Technical Service Bulletin: tsb100117

Rocker Lever Housing Gasket Changes

This Technical Service Bulletin introduces a revised version of the rocker lever housing gasket for use on the K19, K38, and K50 engines.

Fig. 1, Rocker Lever Housing Gaskets (1) Flexible Metal Ring (new) and (2) Rigid Metal Ring (old)

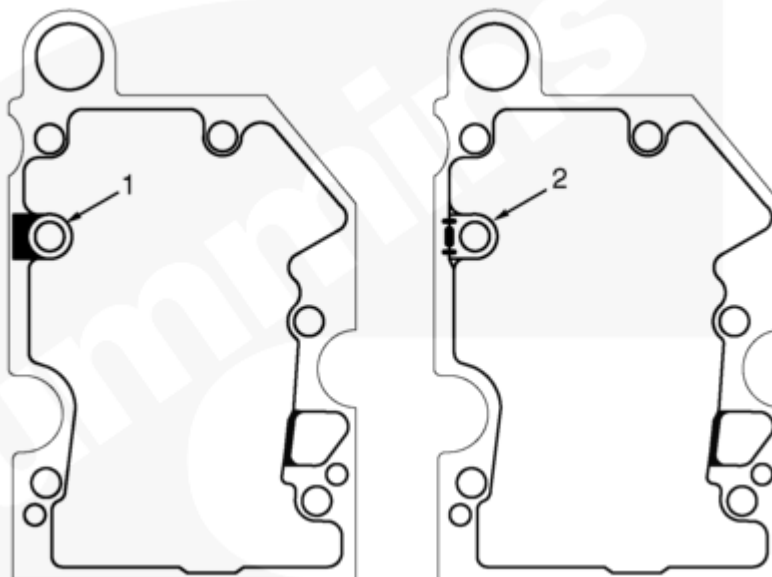
Reports from the field of oil and coolant leaks resulted in the following revisions to the gasket:

- Coining of the steel portion of the gasket was made wider and thicker to distribute the loading, which had caused some of the old gaskets to split.

- The seal for a capscrew hole that is inside the housing (**always** nearest the intake valves) was changed to a metal washer that is bonded with an elastomer to the steel portion of the gasket. The previous version had **only** the elastomer.
- The two capscrew holes nearest the water passage were changed to add more steel so that approximately half of the seal circumference is steel and half is elastomer.

When installing the gasket, make certain that all sealing surfaces are aligned properly, particularly around the large water transfer hole. This should be done by looking at the gasket from the side/edge before installation. If the gasket is **not** flat (i.e., has 'twist' in it) or is distorted, do **not** use it. Also, check the gasket, once it has been installed, to make certain that all of the holes are aligned.
